Doc or ECO #:	ECO-PN4-003-007	Date:	09/11/2018	Author:	GD
	Rev. #:	A				
Replacing obsolete 384V to 12V DC-DC	Engineering Approval:	aeg	Date:	09/11/2018	Quality Approval	DO

P/N #:	PN4-003	Effective Date:	September 11, 2018
Title:	Modification to accommodate new 384V to 12V DC-DC converter changes

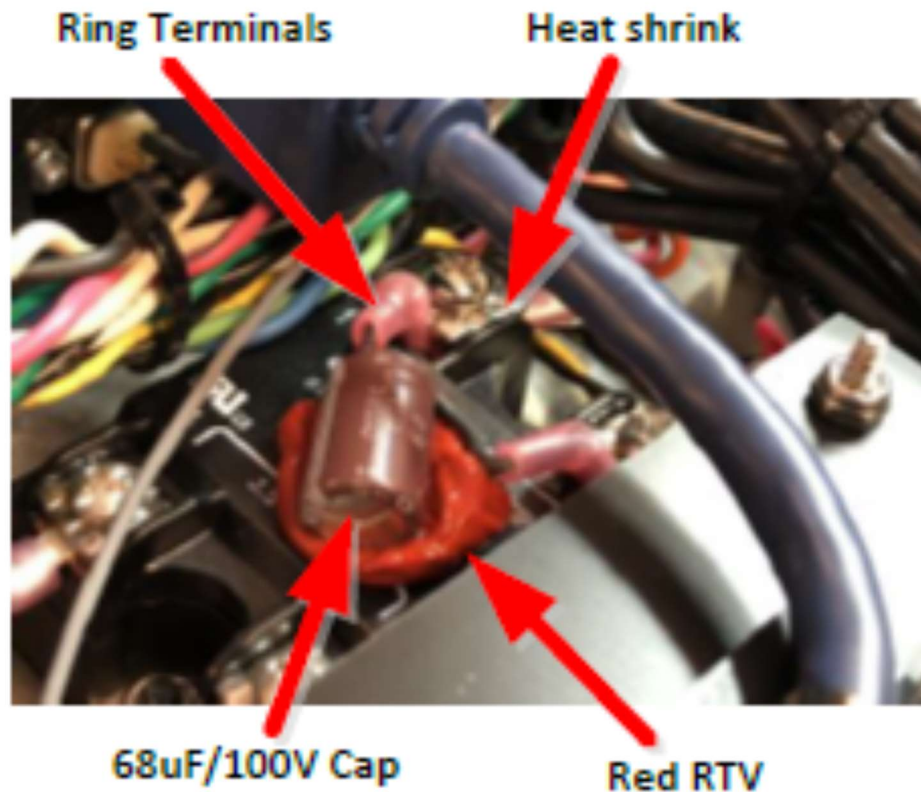
The new converter has slightly different electrical characteristics compared to the obsolete converter. These minor changes have caused the tether voltage to not switch on correctly when the ROV is connected to the ICB panel without a tether.

To rectify this issue a 68uF/100V Aluminum electrolytic capacitor is added across the output of the main solid-state relay which controls the switch ON/OFF function of tether voltage. The capacitor is retained

with Red RTV to breaking off due to vibrations during shipping as shown in the photo below (next page). The retaining method may be improved via another ECO near future.
